Rebuttal Evidence to OBJ-14 (Cambridge Past Present and Future)

**The Transport and Works (Inquiries Procedure)
Rules 2004**

January 2022

Figure 1 – Rail Systems Compound within CC2 During Construction

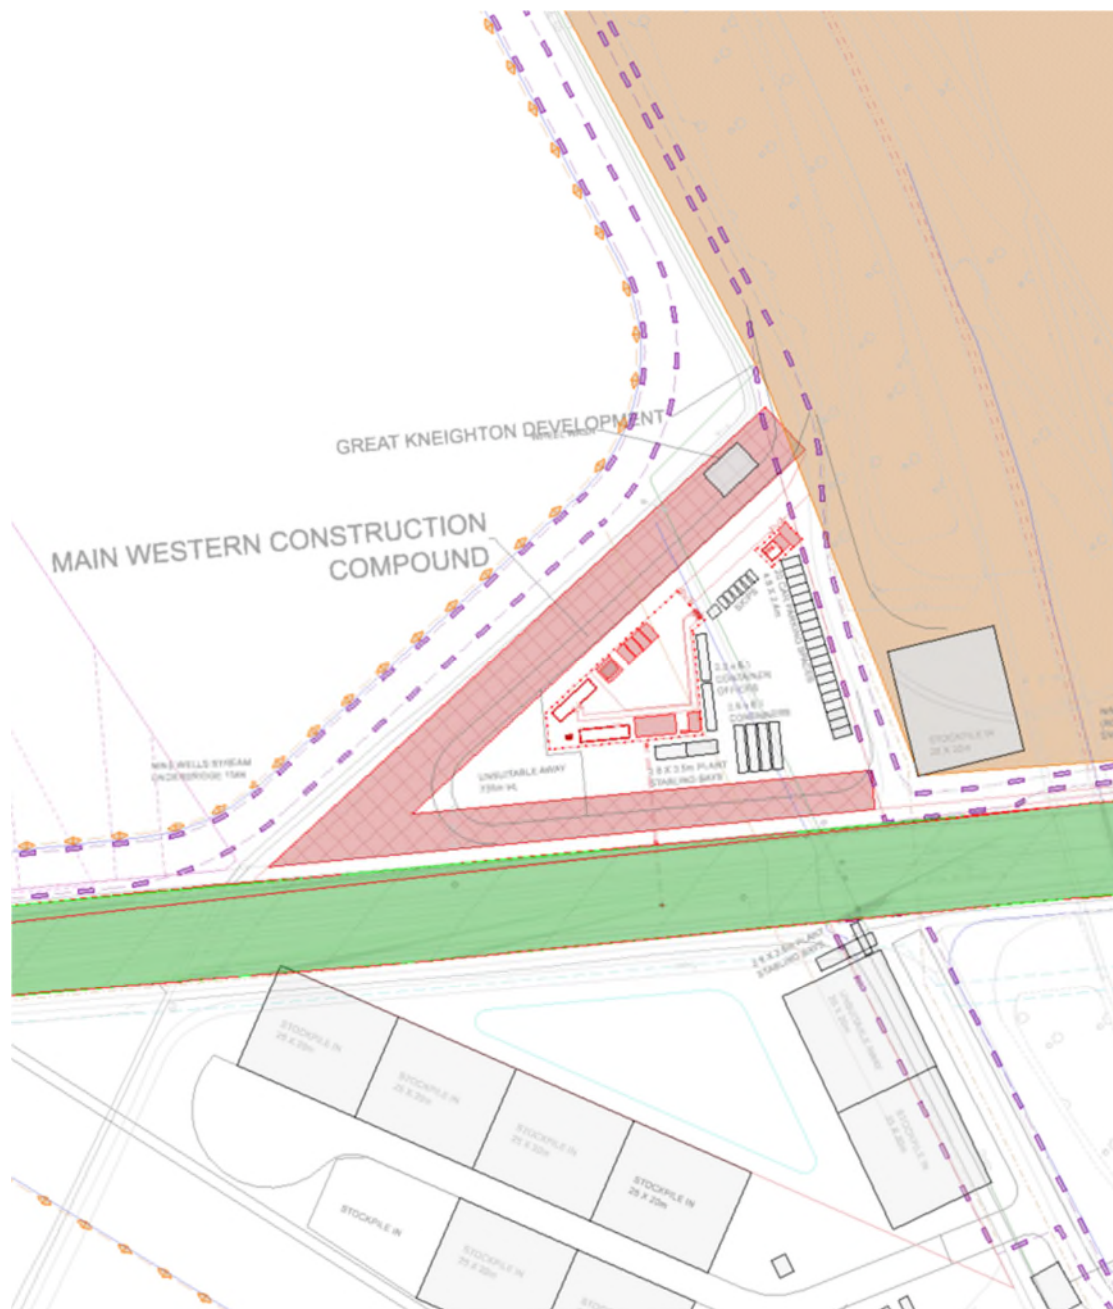
2.3 Section 4 of Mr Littlewood's Proof of Evidence concerns the location of the proposed Rail Systems Compound and landscaping works.

- 2.3.4 In respect of the suggestion that the compound could be moved closer to the railway, the compound is located such that its presence doesn't encumber the simultaneous construction of the works, nor the ability to co-locate a strategic construction compound in the same area whilst avoiding public utilities crossing this site. These constraints dictate the proposed position of the Rail Systems Compound.

- 2.3.5 I have prepared figure 1 to demonstrate the complex space proofing work for the Rail Systems Compound and CC2. The Rail Systems Compound must be constructed within a busy construction compound, laid out with safety in mind to service works on the adjacent railway. When the construction compound is removed at the end of the project, this leaves the RSC as close to the railway boundary as was practically possible.

2.3.7 I conclude that the Rail Systems Compound is located as close to the remodelled railway as practically possible.
